Blackwater Gold Project

Draft Caribou Mitigation and Monitoring Plan – Version 4

March 2022

Figure 1.1-1: Tweedsmuir Caribou Range Habitat in Relation to the Blackwater Project Certified Project Description

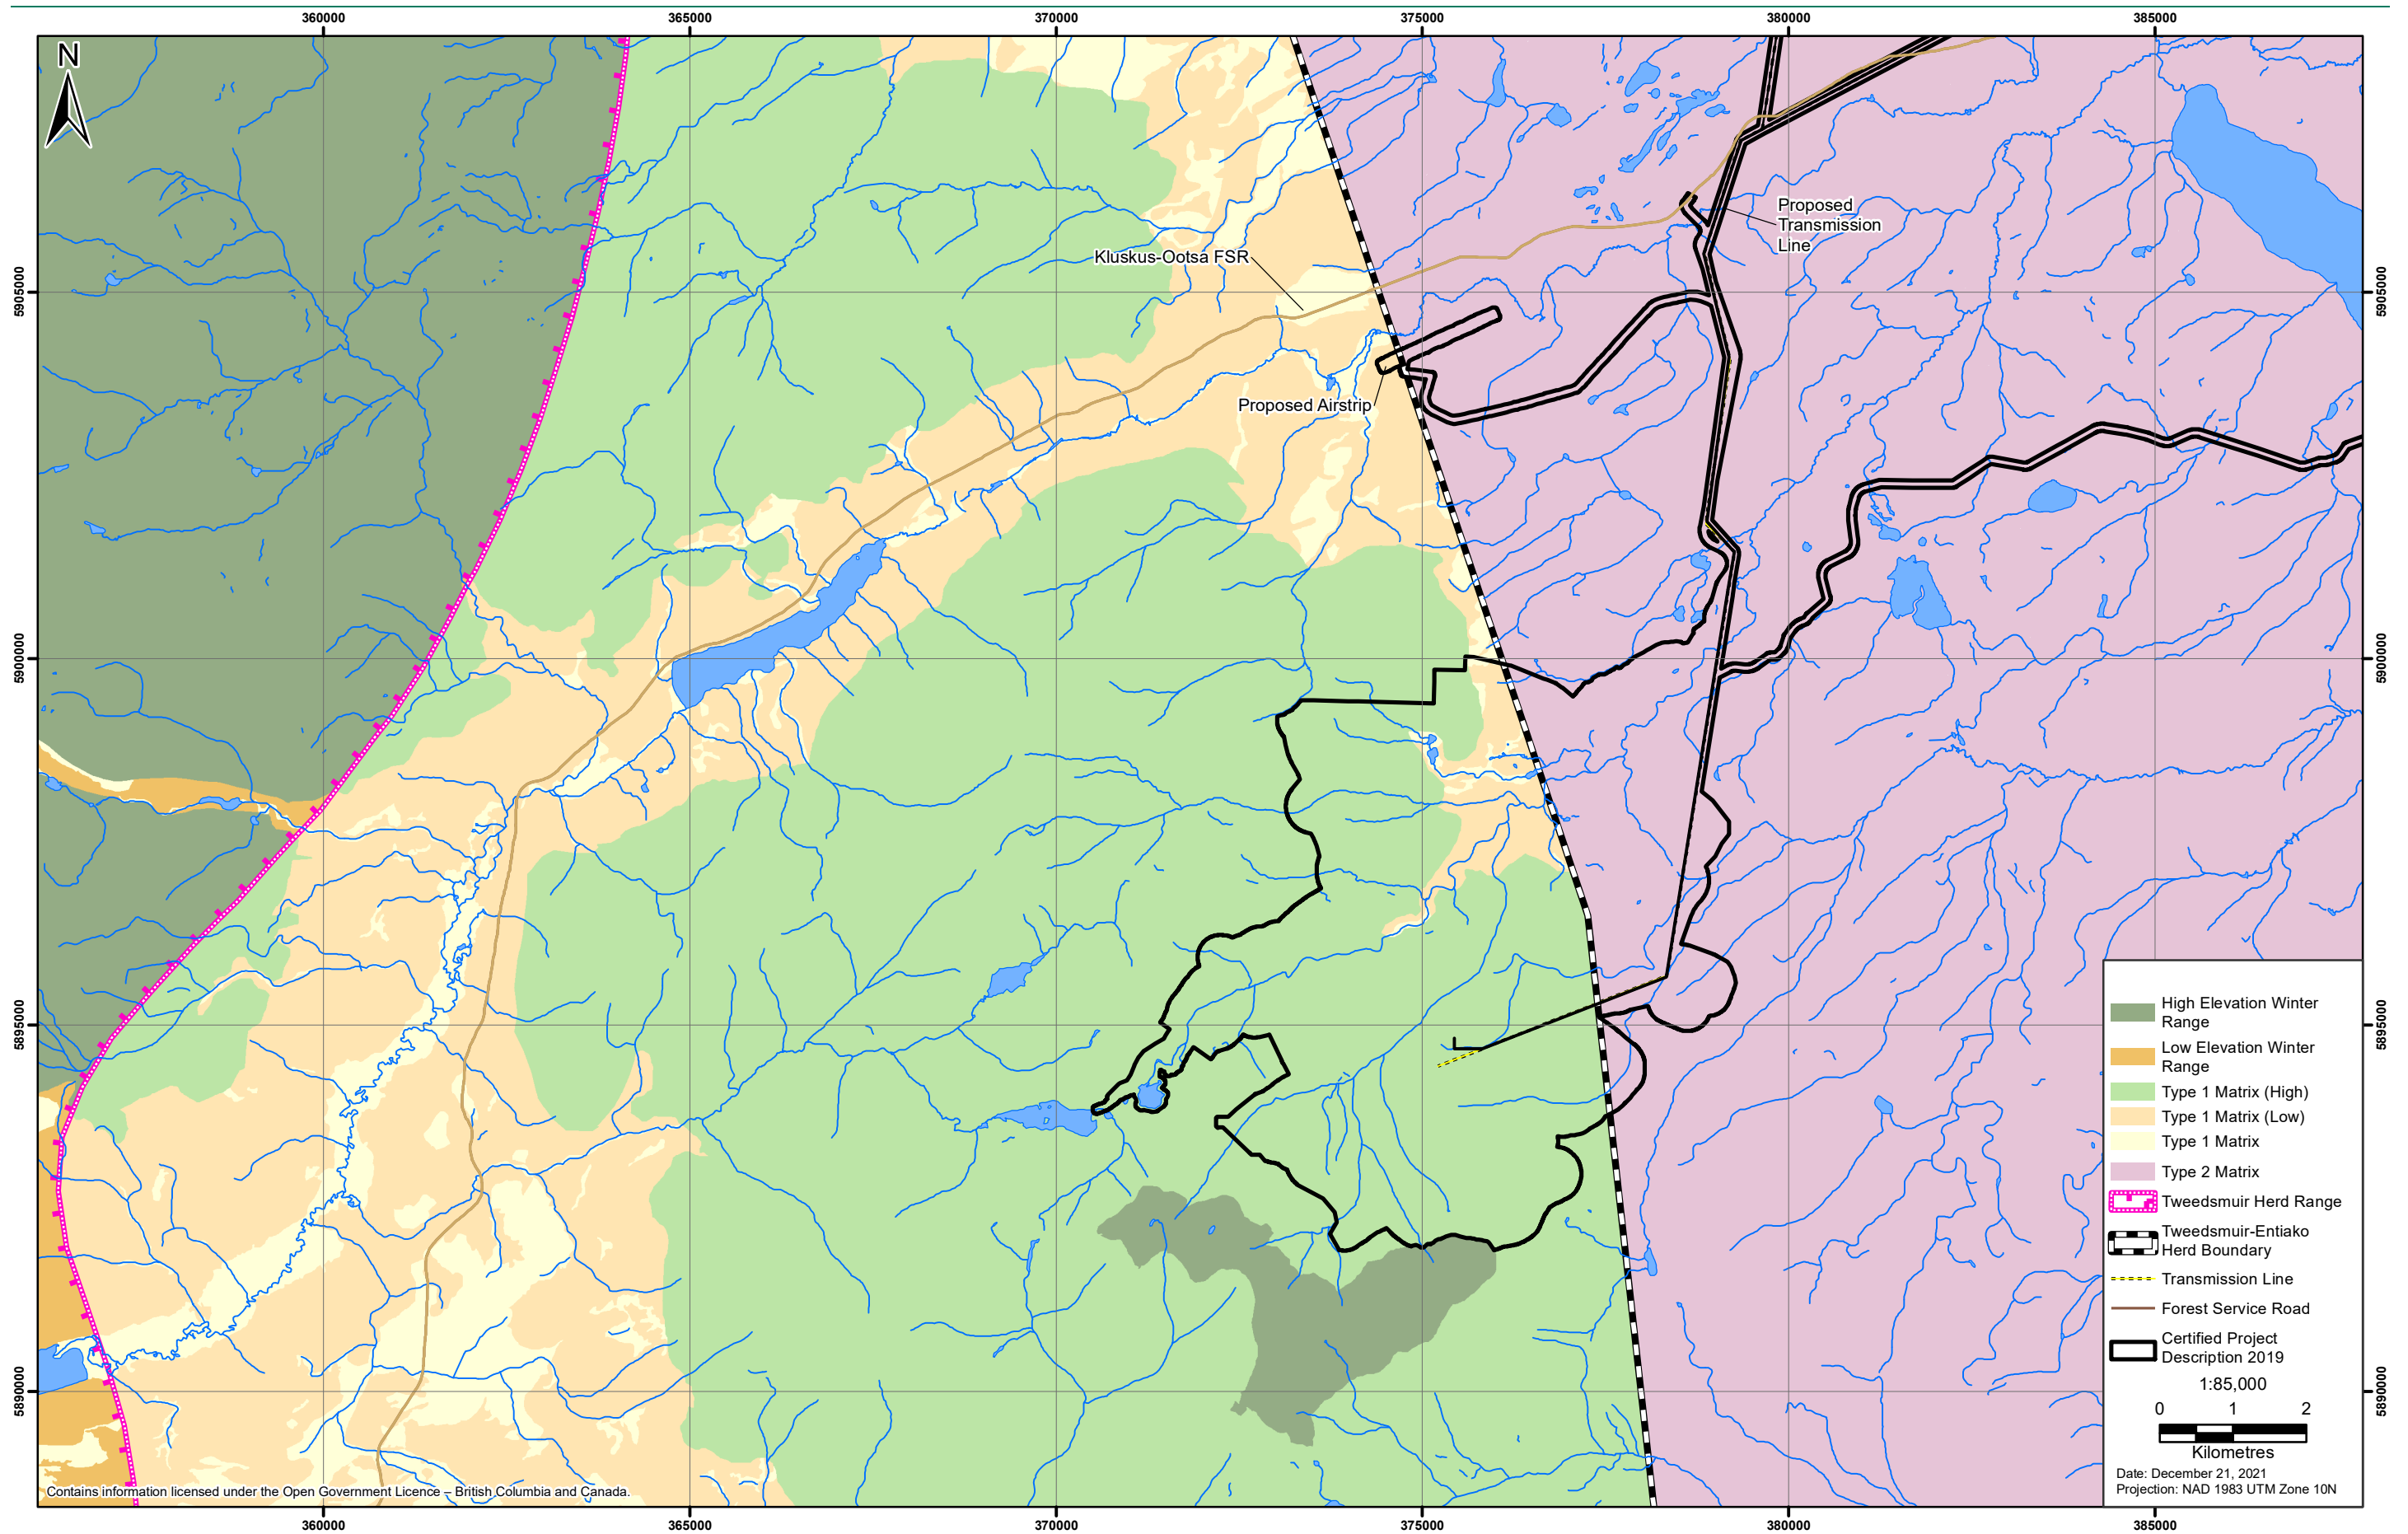
- Buffers and Project Effects – ECCC supports the hybrid 3 km/500 m buffer, which is used in the current draft of the CMMP.
- Mapping – ECCC does not agree with the area mapped as non-CH on Figure 1.1-1. BW Gold has updated this figure for the current CMMP to remove non-CH habitat.

- Habitat Characterization – The characterization of habitats is consisted with the descriptions in the EA except for non-CH habitat identified in Figure 1.1-1. BW Gold has updated this figure for the current CMMP to remove non-CH habitat.

The characterization of habitats in the Draft CMMP aligns with the information in the Environmental Assessment (EA) and is consistent with the mapping and descriptions from the EA. There is one exception; in Figure 1.1-1 within Matrix 1 habitat there is one area within identified as non-critical habitat. All Matrix 1 habitat is characterized as critical habitat. This figure is the only place in the Draft CMMP where Matrix habitat is depicted as non-critical habitat. If the Matrix 1 habitat that was described as non-critical in Figure 1.1-1 was excluded from disturbance calculations the resultant disturbance percentages would be incorrect.

ECCC notes that there is no explanation or definition of "non-CH" in Fig 1.1-1: Tweedsmuir Caribou Range Habitat in Relation to the Blackwater Project Certified Project Description. We assume it aligns with the note under Table 4-1 of the 2018 Updated Effects Assessment and Significance Determination which states "In habitat suitability, non-critical habitat is that habitat with high densities of linear features or a high degree of fire or forestry disturbance."
